UNITED STATES PATENT AND TRADEMARK OFFICE

APPLICATION NO.	FILING DATE	FIRST NAMED INVENTOR	ATTORNEY DOCKET NO.	CONFIRMATION NO.
10/629,831	07/30/2003	Akira Tsumiyama	SN-US035024	7279

<p align="center">Office Action Summary</p>	<p>Application No.</p> <p>10/629,831</p>	<p>Applicant(s)</p> <p>TSUMIYAMA, AKIRA</p>	
	<p>Examiner</p> <p>Vinh T. Luong</p>	<p>Art Unit</p> <p>3682</p>

ATTACHMENT # 1

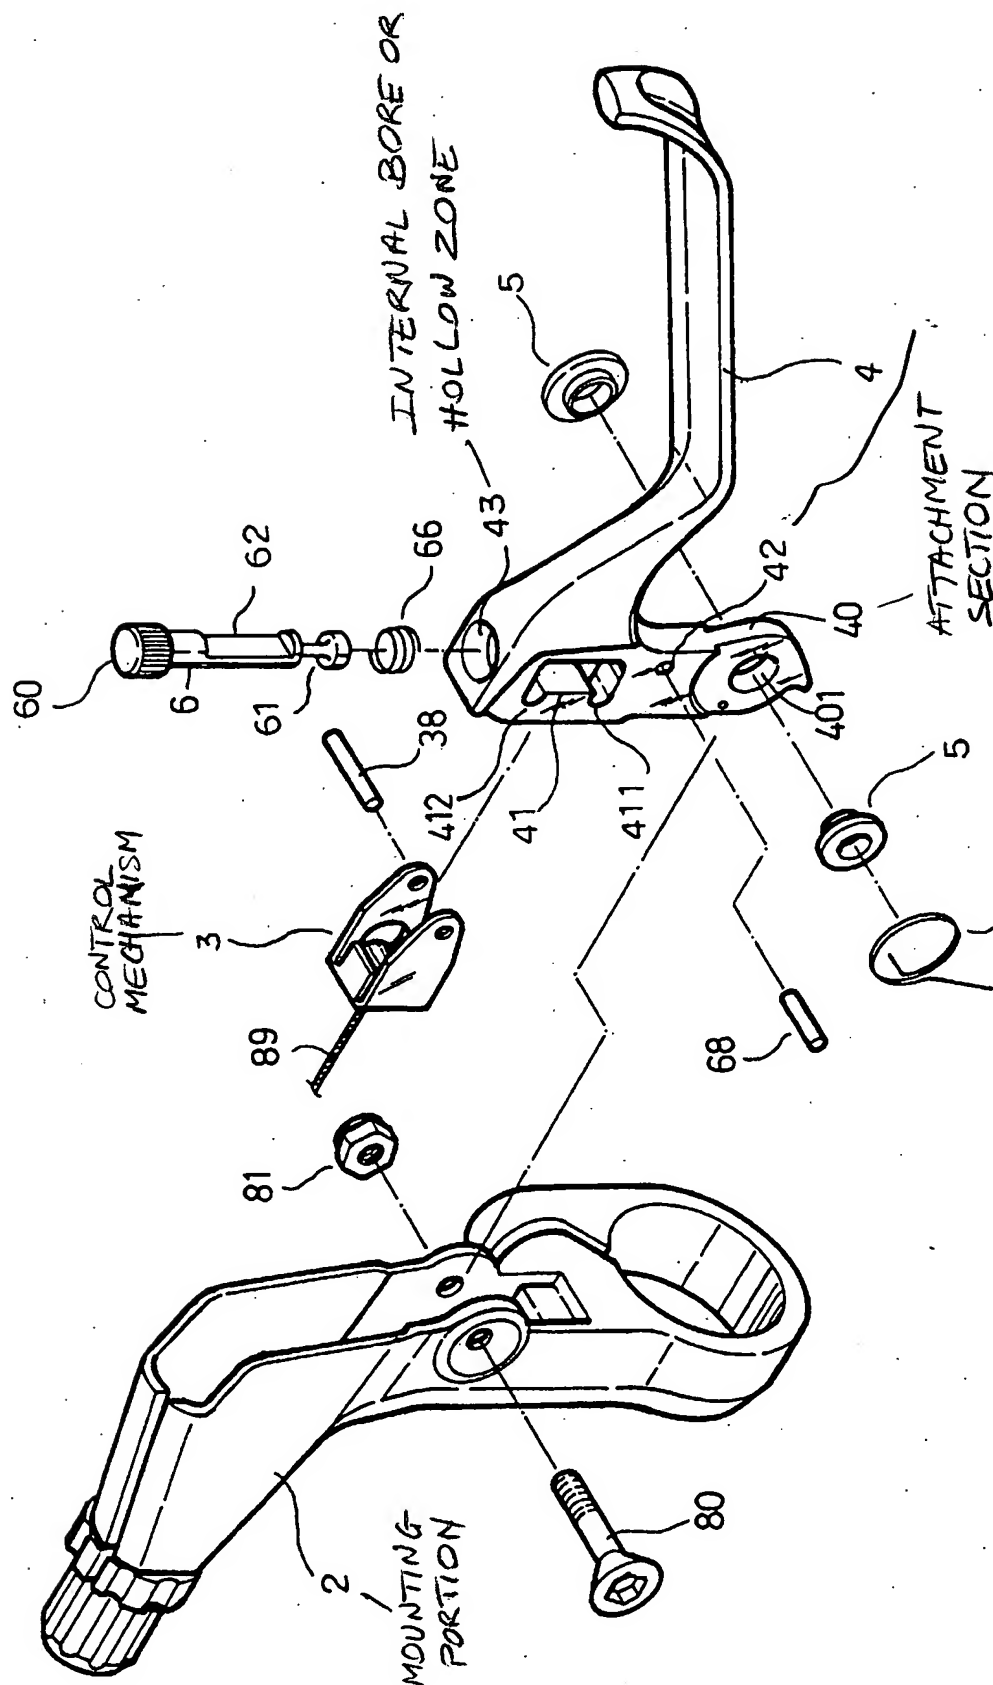
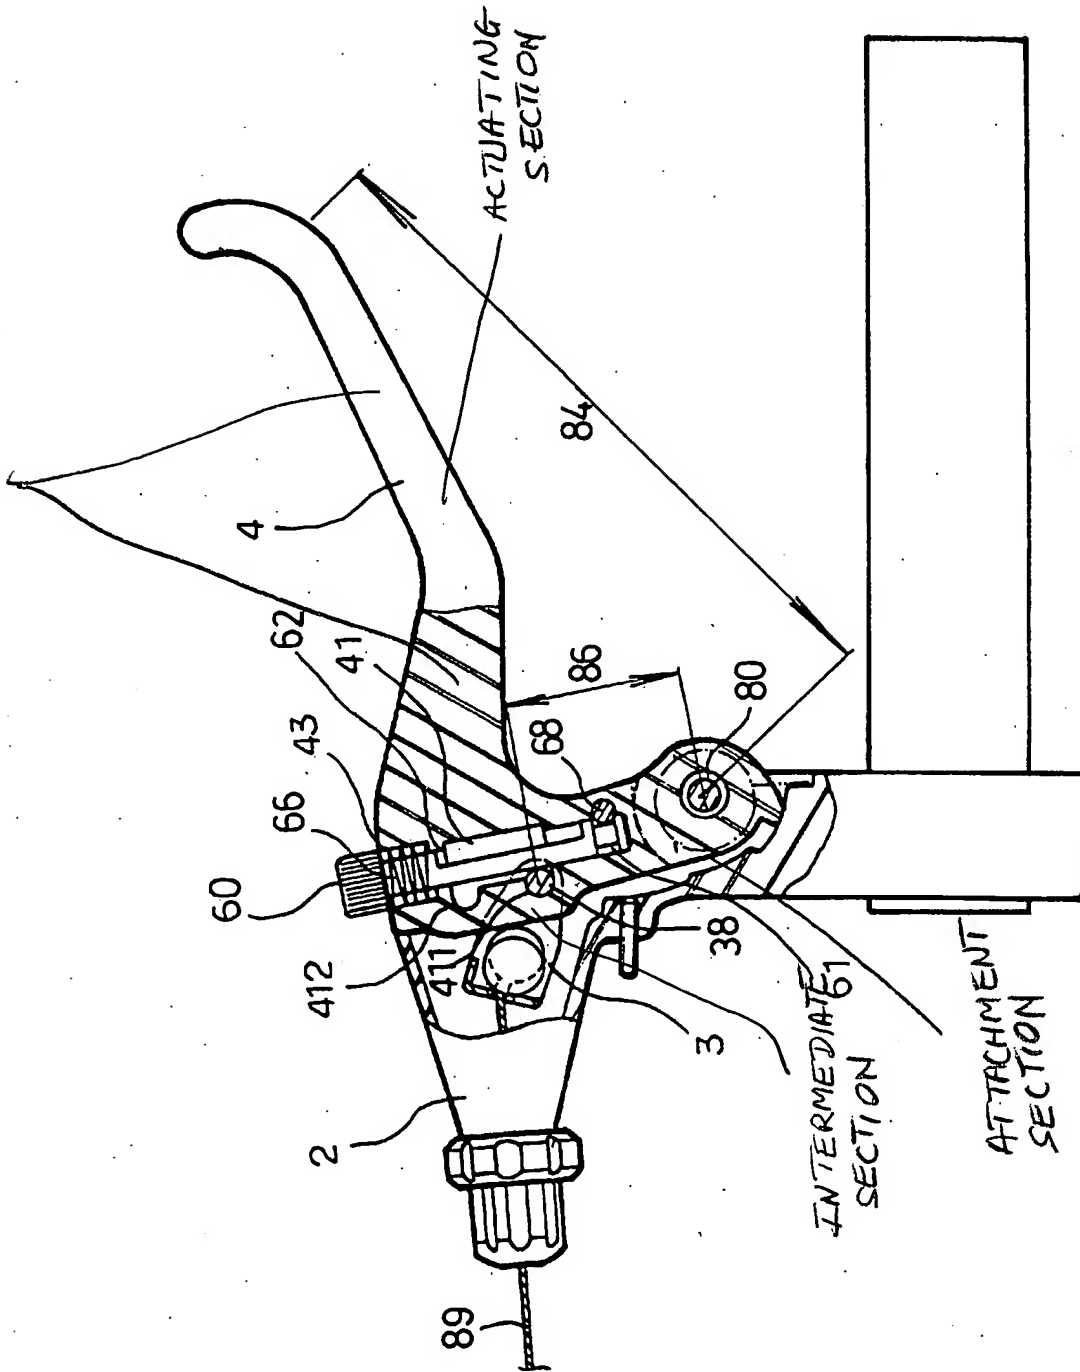
a control lever 4 operatively coupled to the control mechanism 3, the control lever 14 including an attachment section (at 40 in Fig. 1, see Attachment 1), an intermediate section (Att. 1) extending from the attachment section (Att. 1) and an actuating section (Att. 1) extending from the intermediate section (Att. 1), the attachment section (Att. 1) being operatively coupled to the control mechanism 3, *at least one of* the intermediate section (Att. 1) and the actuating section (Att. 1) having a hollow zone 43 formed therein that extends axially along the at least one of the intermediate section (Att. 1) and the actuating section (Att. 1) of the control lever 4, the control lever 4 being constructed of a material having an internal bore 43 (Fig. 1) extending axially to form the hollow zone 43 with the internal bore being surrounded by

the material along a majority of an axial length of the internal bore 43, the internal bore 43 having a substantially circular transverse cross-sectional shape 43 such that the control lever 4 has a non-uniform wall thickness (Att. 1) as measured in a direction transverse to the axially extending internal bore between the internal bore 43 and an external surface of the at least one of the intermediate section (Att.) and the actuating section having the hollow zone 43 formed therein.

Chen teaches the invention substantially as claimed. However, Chen does not explicitly teach to form the lever of cast material.

Regarding claim 5, Chen's hollow zone 43 is formed in the intermediate section and has a plug 60 mounted therein at a free end of the intermediate section to form the hollow interior area 43. To rearrange the location of Chen's hollow zone 43 to the actuating section would have been a matter of choice in design because the claimed structure and the function it performs are the same as the prior art. *In re Chu*, 66 F.3d 292, 36 USPQ2d 1089 (Fed. Cir. 1995). See also legal precedents regarding rearrangement of parts in MPEP 2144.04.

a control lever 4 operatively coupled to the control mechanism 3, the control lever 14 including an attachment section (at 40 in Fig. 1, see Attachment 1), an intermediate section (Att. 1) extending from the attachment section (Att. 1) and an actuating section (Att. 1) extending from the intermediate section (Att. 1), the attachment section (Att. 1) being operatively coupled to the control mechanism 3, *at least one of* the intermediate section (Att. 1) and the actuating section (Att. 1) having a hollow zone 61 formed therein that extends axially along the at least one of the intermediate section (Att. 1) and the actuating section (Att. 1) of the control lever 4, the hollow zone 61 being a blind bore that is open at a free end of the intermediate section (Att.).

Chen teaches the invention substantially as claimed. However, Chen's hollow section is at the intermediate section. To rearrange the location of Chen's hollow zone 61 to the actuating section would have been a matter of choice in design because the claimed structure and the function it performs are the same as the prior art. *In re Chu, supra*. See also legal precedents regarding rearrangement of parts in MPEP 2144.04, *supra*.

ATTACHMENT # 2

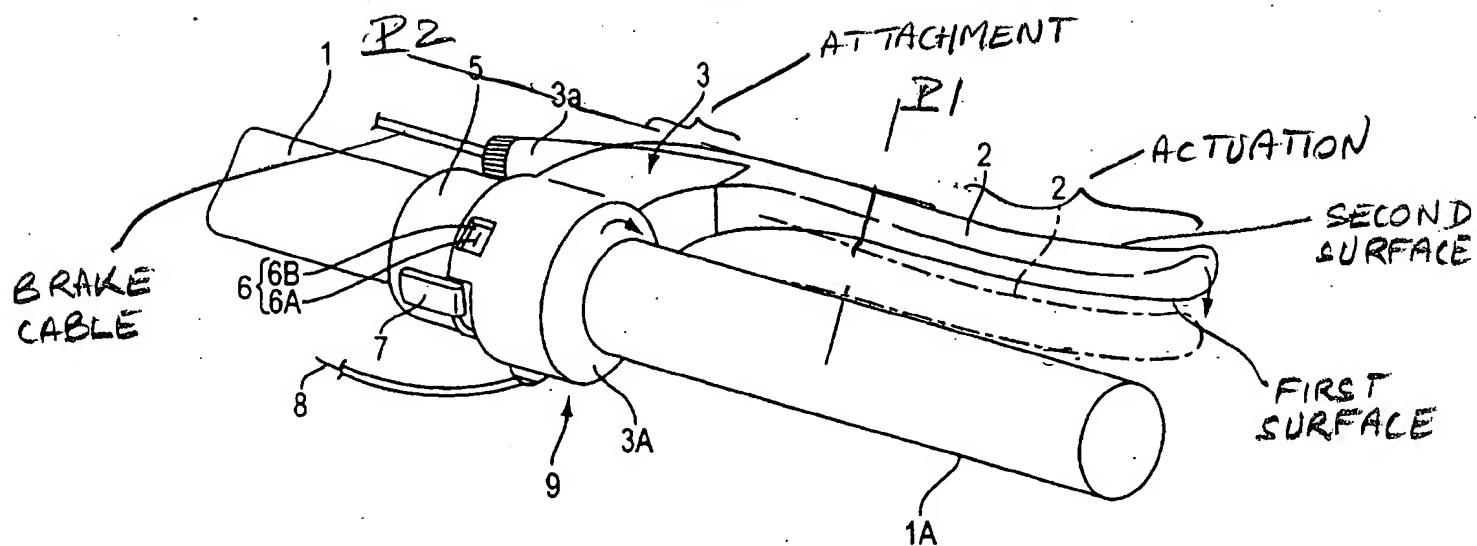
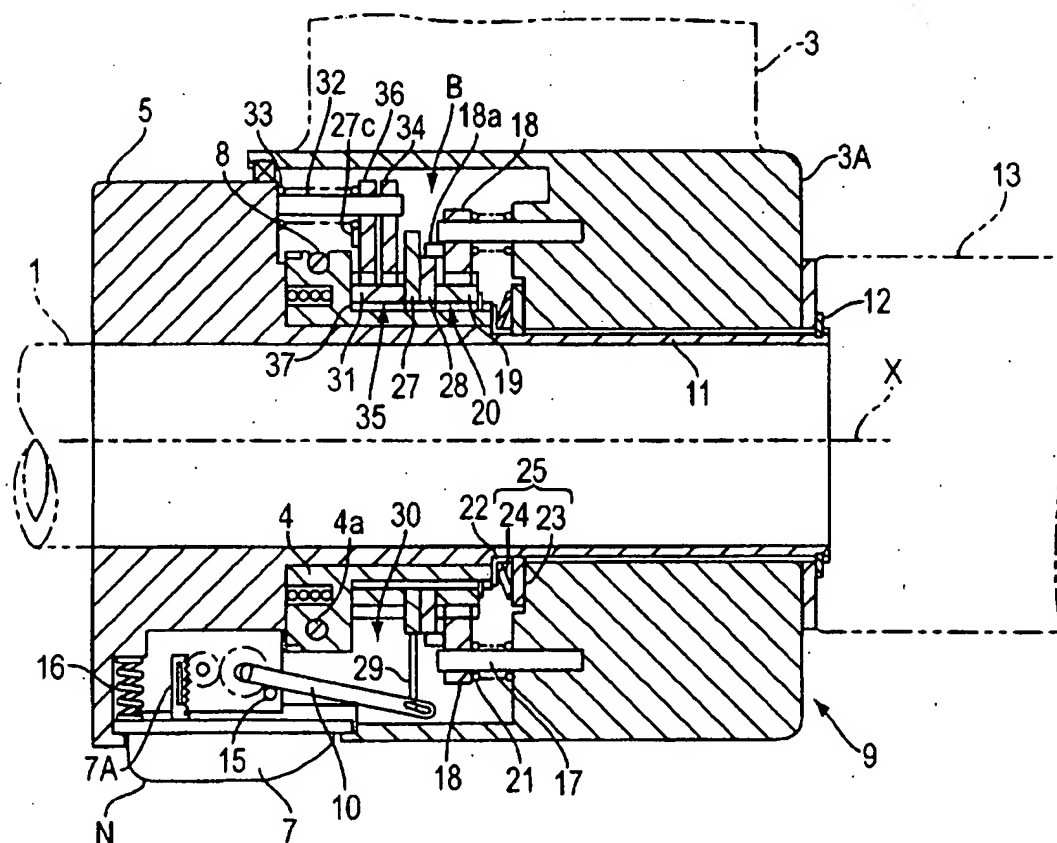
a control lever 2 or 2, 40 operatively coupled to the control mechanism 9 to move along a first plane (P1. See Attachment 2) between a rest position and a operating position and along a second plane (P2, Att. 2) substantially perpendicular to the first plane (Att. 2) between the rest position and a first position vertically spaced from the rest position, the control lever 2 or 2, 40 including an attachment section (Att. 2) and an actuating section (Att. 2) extending from the attachment section (Att. 2), the attachment section (Att. 2) being operatively coupled to the control mechanism 9, the actuating section (Att. 2) having a first actuation surface extending in a direction substantially perpendicular to the first plane and an inclined second actuation surface (Att. 2) facing substantially away from the first actuation surface (Att. 2) downwardly and towards the handlebar 1, 1A, the inclined second actuation surface (Att. 2) extending in a direction intersecting the first and second planes, the inclined second actuation surface (Att. 2) having a transverse height that is at least one-half of the transverse height of the first actuation surface (Att. 2) with the transverse heights being measured in directions perpendicular to the first plane (P1).

Furuta teaches the invention substantially as claimed. However, Furuta does not teach the size or dimension such as the transverse height of the first actuation surface being more than half of an overall transverse height of the actuating section as measured in directions perpendicular to the first plane.

It is common knowledge in the art to change the size/dimension of Furuta's transverse height of the first actuation surface as claimed in order to improve the leverage of the lever. The size or dimension of the transverse height of the first actuation surface as claimed would have been a matter of choice in design because the claimed structure and the function it performs are the same as the prior art. *In re Chu, supra*. See also change in size or dimension in MPEP 2144.04.

Regarding claim 12, the control lever 2 or 2, 40 includes a brake cable attachment portion arranged and configured to pull a brake control cable (Fig. 1, Att. 2) upon movement of the control lever 2 or 2, 40 from the rest position to the operating position when a substantially rearward force is applied to the first actuation surface (Att. 2).

Regarding claim 13, the control lever 2 or 2, 40 is normally biased toward the rest position in order to release the brake control cable (Att. 2) after moving the control lever 2 or 2, 40 to the operating position and releasing the control lever 2 or 2, 40.
